# PLAT COMMITTEE

September 11, 2023 @ 4:00 p.m.

**BLOOMINGTON PLAT COMMITTEE**  
**STAFF REPORT**  
**Location: 1100 South Brooks Drive**

**CASE #: DP-30-23 / PLAT2023-07-0009**  
**DATE: September 11, 2023**

**SITE IMPROVEMENT PLAN**

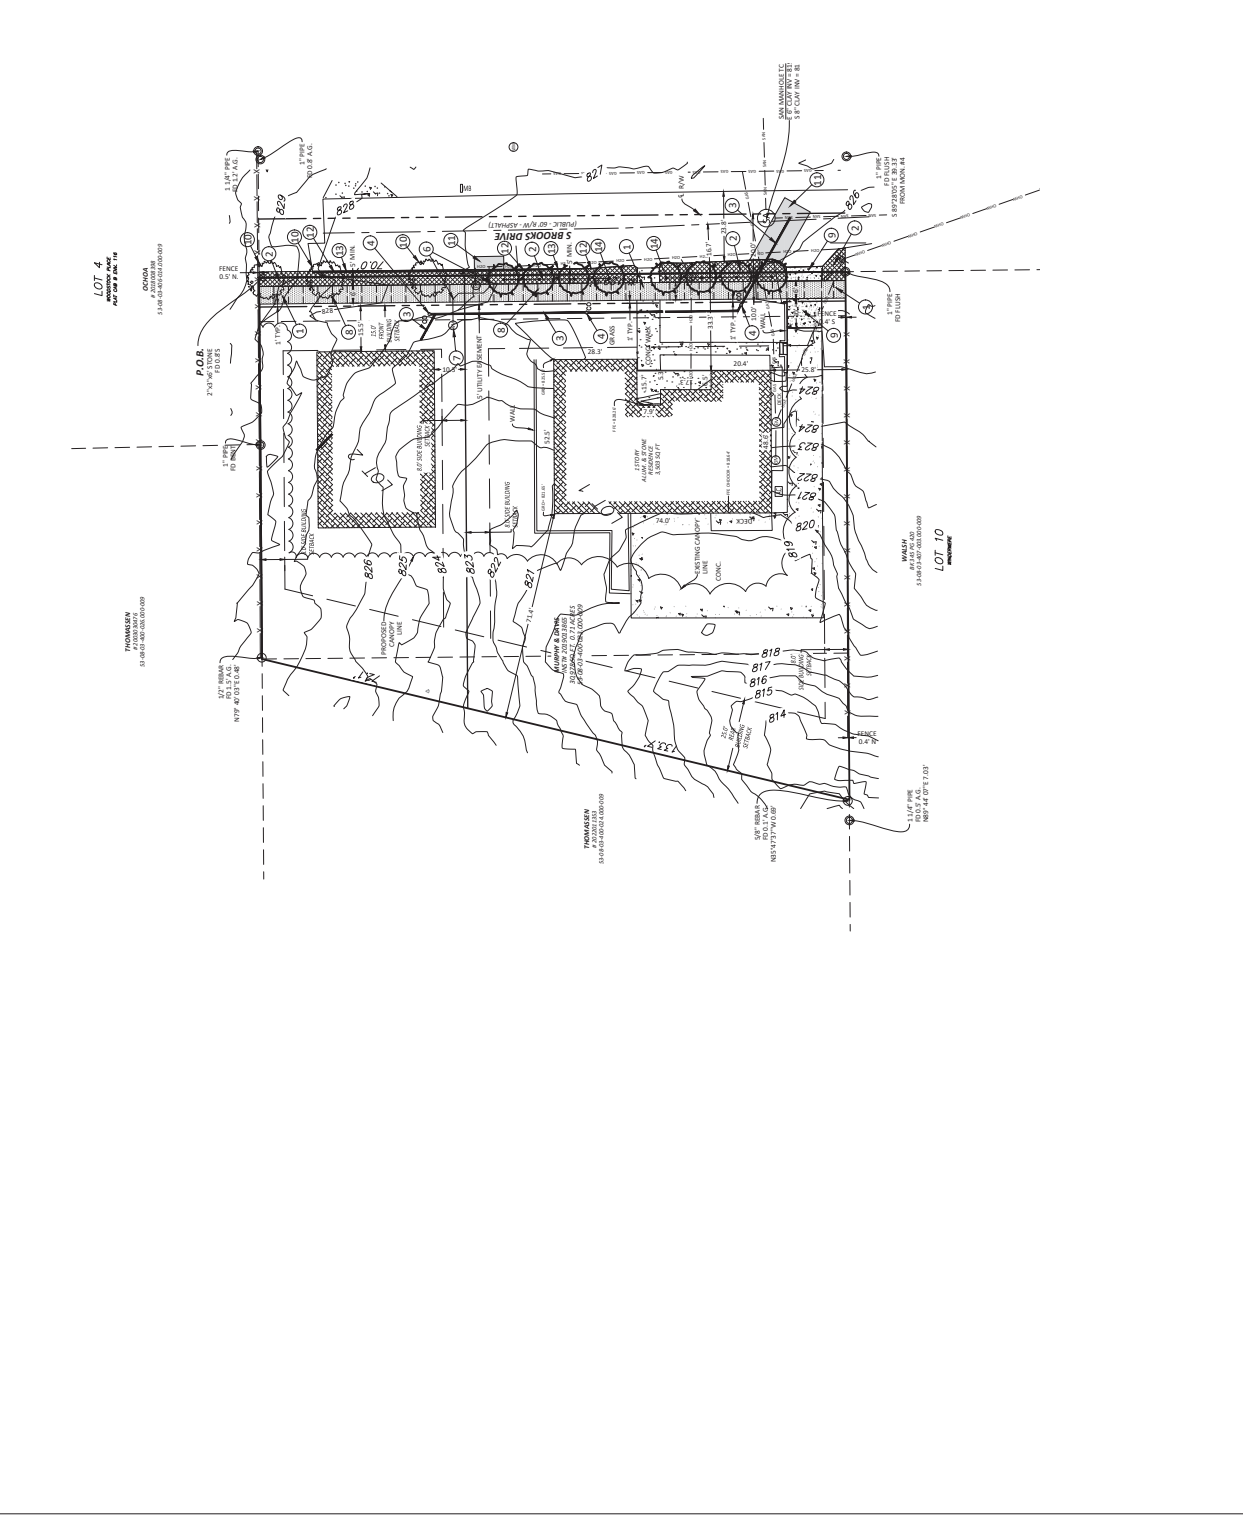
In this case, because the paved roadway is not aligned (not parallel) with the existing right-of-way, and is laid out somewhat arbitrarily within the right-of-way, the Department has determined that the required additional width for this subdivision shall be measured from the center of the existing recorded right-of-way. The proposed plat dedicates an additional 10 feet of right-of-way width along Brooks Drive, bringing the west side of the street up the proposed 30 feet from the center of the right-of-way.

**Pedestrian facilities and tree plot:** Public improvements in the public right-of-way, including newly dedicated right-of-way, are required to comply with the standards in the Transportation Plan. Brooks Drive is designated as the Neighborhood Residential street typology in the Transportation Plan. The design parameters in table 5 of the Transportation Plan call for a six-foot-wide sidewalk and a five-foot-wide greenscape (tree plot) between the sidewalk and the curb (or edge of pavement) on Neighborhood Residential Streets.

The proposed plat provides the required six-foot-wide sidewalk and five-foot-wide tree plot along the entire frontage of both lots. To ensure the required tree plot width, the site improvement plan indicates areas to remove existing roadway pavement.

**Street trees:** The combined frontage of proposed lots 1 and 2 is approximately 200 feet, which requires at least seven large street trees. Large street trees must be planted at least 10 feet from public utility lines; where this isn't possible, medium or small street trees can be planted instead, in a quantity at least double the requirement for large trees. There is an existing CBU-owned public water line in existing right-of-way within five feet of the proposed tree plot location adjacent to proposed lot 1. The proposed plat provides three large street trees along the frontage of lot 2 where there is more than 10 feet of separation, and eight small street trees along the frontage of lot 1 where there is less than five feet of separation from the public water line.
